Channel Characteristics (83D.4)

Ryan Latchman, Mindspeed

Channel in D1.1

Figure 83D-2—Chip-to-chip insertion loss budget at 12.89 GHz

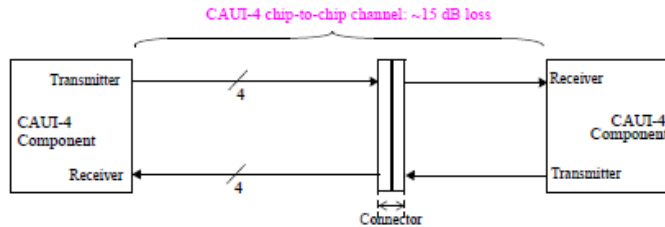
Channel Update

CAUI-4 chip-to-chip channel

The normative channel compliance is through CAUI-4 COM as described in 83D.4. Actual channel loss could be higher or lower due to the channel ILD, return loss, and crosstalk.

Figure 83D-3—CAUI-4 chip-to-chip channel insertion loss

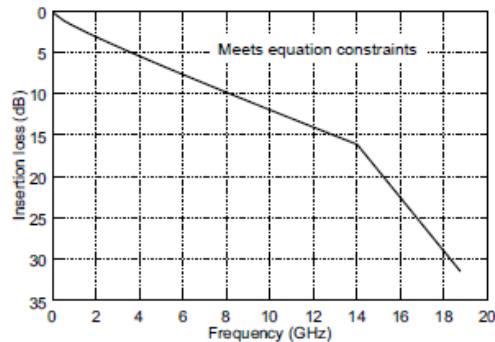
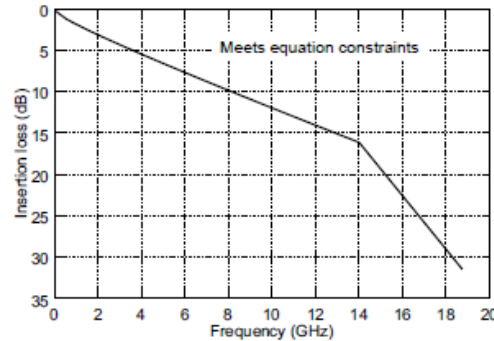
EDITORS NOTE: Insertion_loss equation is TBC

$$\text{Insertion_loss}(f) \leq \left\{ \begin{array}{ll} 1.614(0.075 + 0.537\sqrt{f} + 0.566f) & 0.01 \leq f < 14 \\ 1.614(-18 + 2f) & 14 \leq f < 18.75 \end{array} \right\} \text{ (dB)} \quad (83D-1)$$

$$Insertion_loss(f) \leq \begin{cases} 1.614(0.075 + 0.537\sqrt{f} + 0.566f) & 0.01 \leq f < 14 \\ 1.614(-18 + 2f) & 14 \leq f < 18.75 \end{cases} \text{ (dB)} \quad (83D-1)$$
